APPEAL SUMMARY

Appeal ID: 20765

Project Address: 7607 N Albina Ave

ORSC AG 105.2

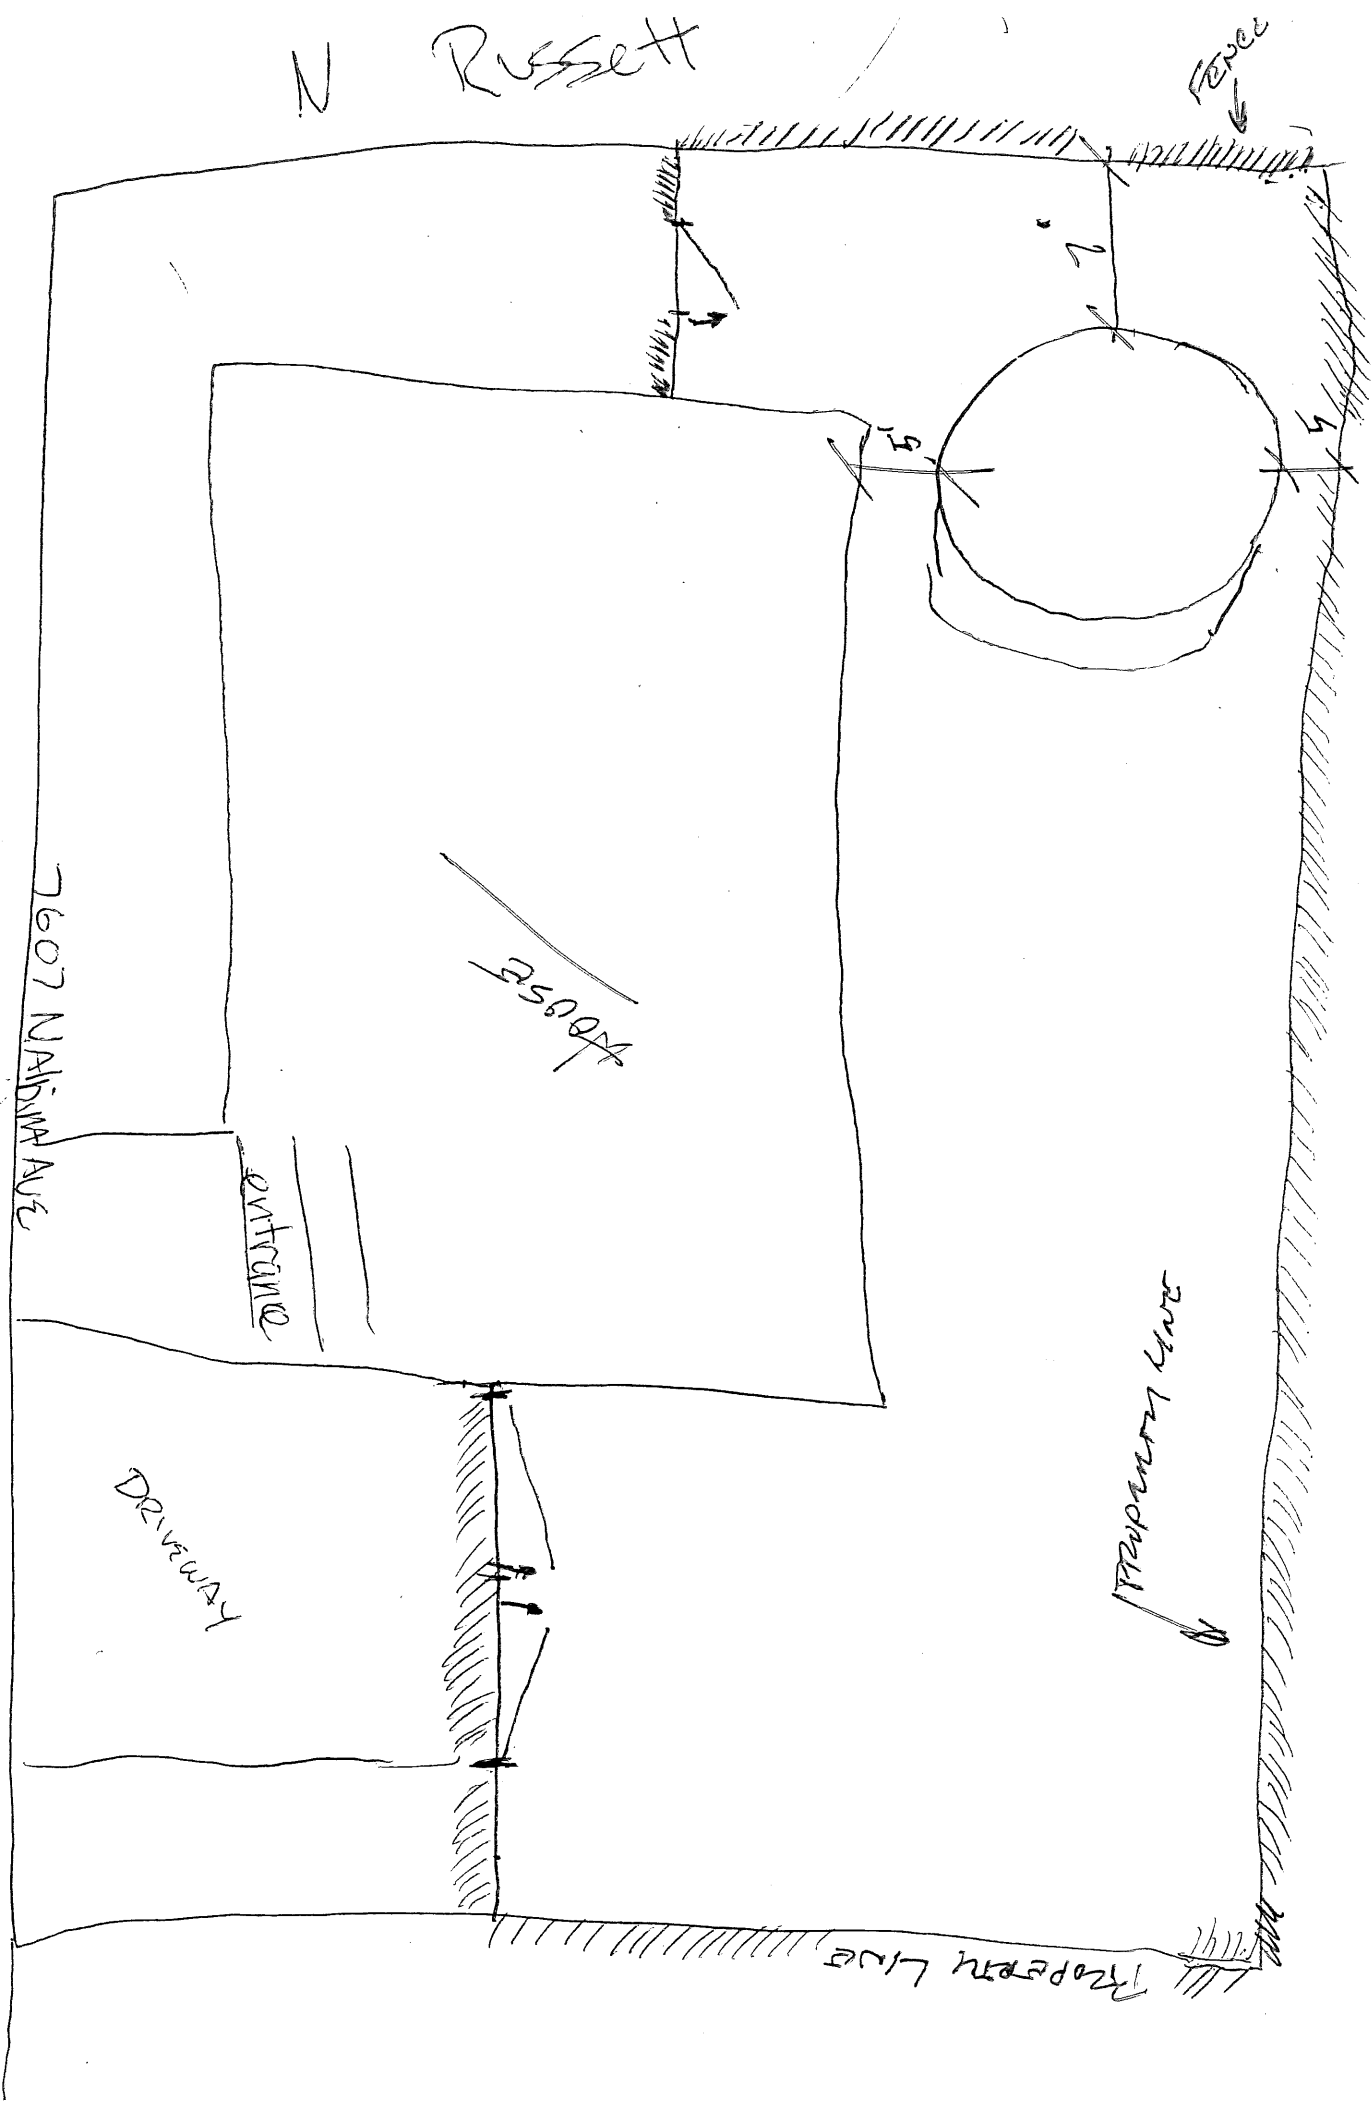
I'd like to appeal the requirements of self closing/latching and opening outward regulations as I keep the gates padlocked when the pool is up.

I'd like to appeal to allow my 7 ft fence , which encloses my entire backyard with two gates (kept padlocked) and which open inward with latches that are self latching as they do latch when gate is pushed closed or the springs on gate close them.

Pool enclosure with 2 in-swing gates with padlocks: Denied. Proposal does not provide equivalent Life Safety protection.
